# Shim6 protocol changes

draft-ietf-shim6-proto-04.txt

# Context Recovery

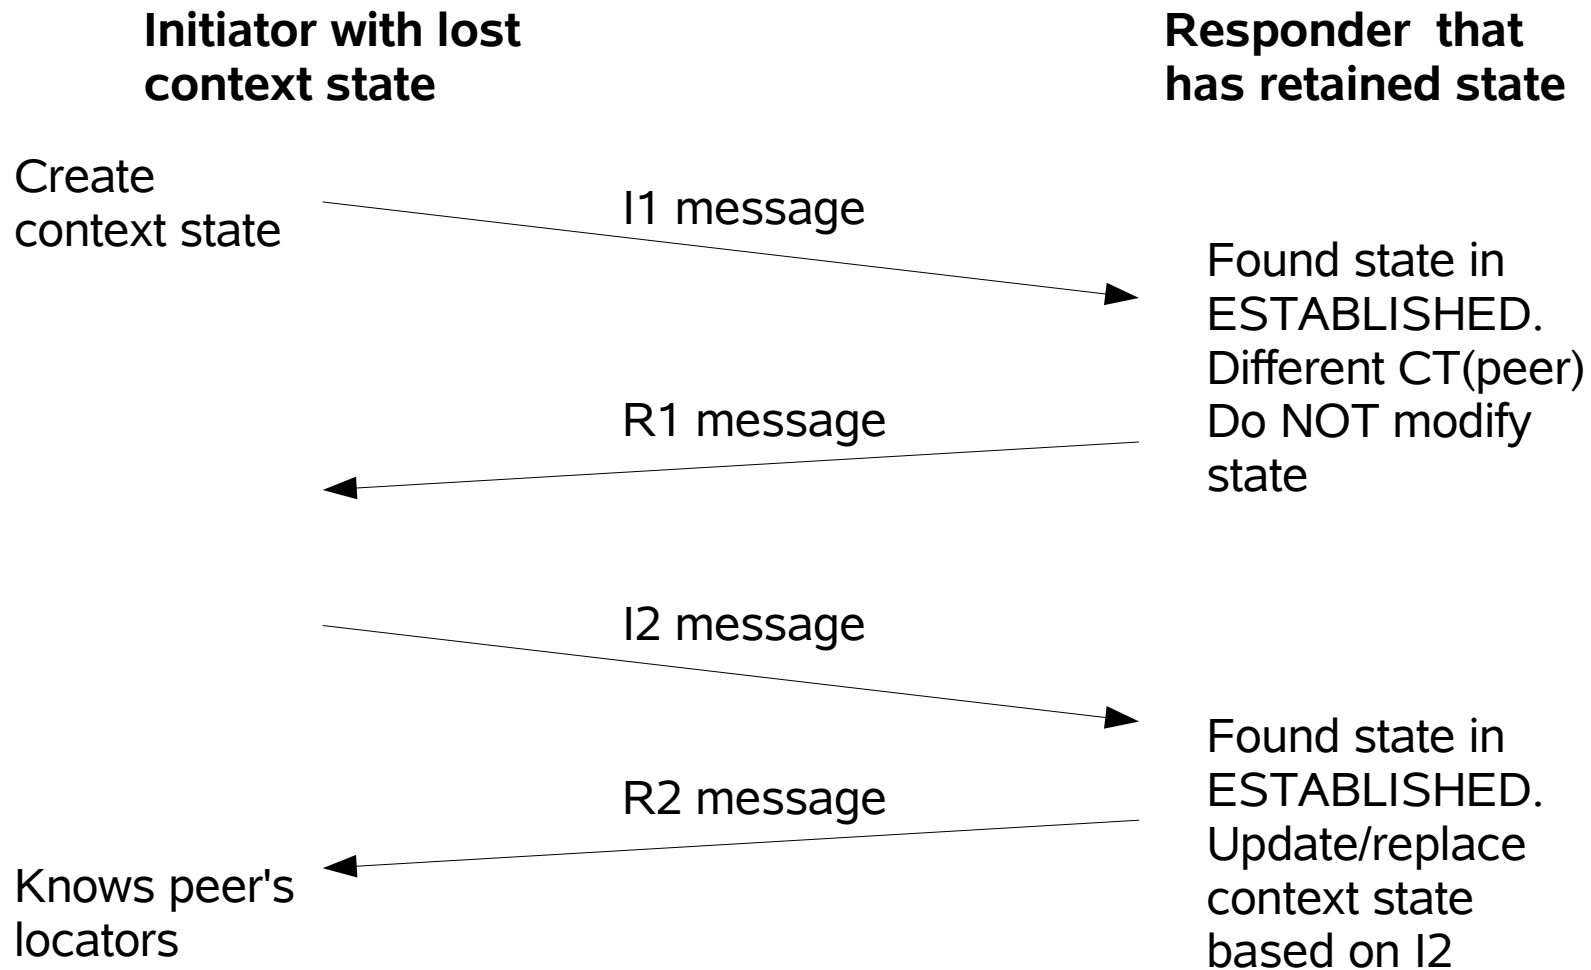
- Added retransmission rules for I2bis (copied from I2 rules)
- Fixed security hole where a single message (I1) could cause CT(peer) to be updated. Now a three-way handshake is required before CT(peer) is updated for an existing context
- Implies 4 message context recovery in one case that had two messages before
  - Next slide
